U.S. Department  
of Transportation  
**Federal Highway  
Administration**

Thank you for your letter of November 19 to Mr. Thomas O. Willett requesting the Federal Highway Administration's (FHWA) acceptance of "Timbrex" composite material blockouts for use in strong steel post w-beam guardrail. Our letter of September 1 granted acceptance for Timbrex blockouts for use in strong-wood-post guardrail only. At our recommendation, you had two full-scale crash tests conducted by Southwest Research Institute to assess blockout performance when used on steel posts. Your letter transmitted the two crash-test reports dated November 1992, and 16-mm films of the tests, as well as a drawing of the blockouts. A copy of the drawing is enclosed.

Supplement to Geometric and Roadside Design Acceptance Letter B-20

GUARDRAIL OFFSET BLOCKOUT FOR USE WITH W 6 X 9 STEEL POSTS

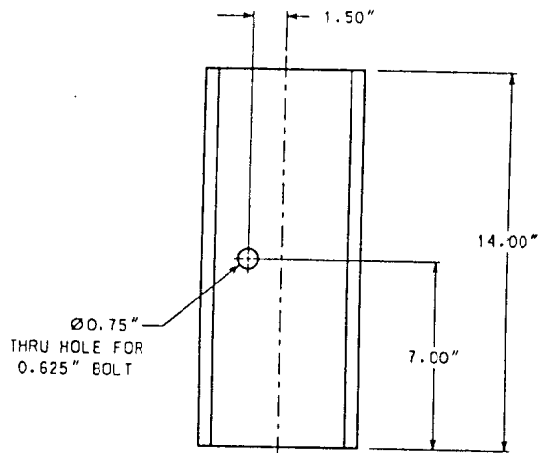
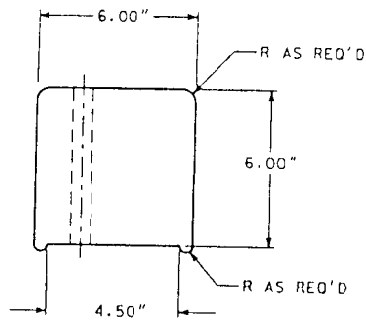
The results meet the velocity, acceleration, and post-impact trajectory requirements of National Cooperative Highway Research Program Report 230. Therefore, 152-mm x 152-mm (6-inch x 6-inch) Timbrex blockouts as a one-for-one substitute for blockouts on G4(1S) guardrail are acceptable for use on Federal-aid projects, within the range of conditions tested, if proposed by a State.

The w-beam backup plates that are normally required at non-splice posts were omitted from the tested system. These plates prevent tearing of the w-beam when contacting a steel blockout. The tested w-beam showed no evidence of shearing in the area of the intermediate posts, therefore, use of backup plates is not considered necessary when using Timbrex blockouts.
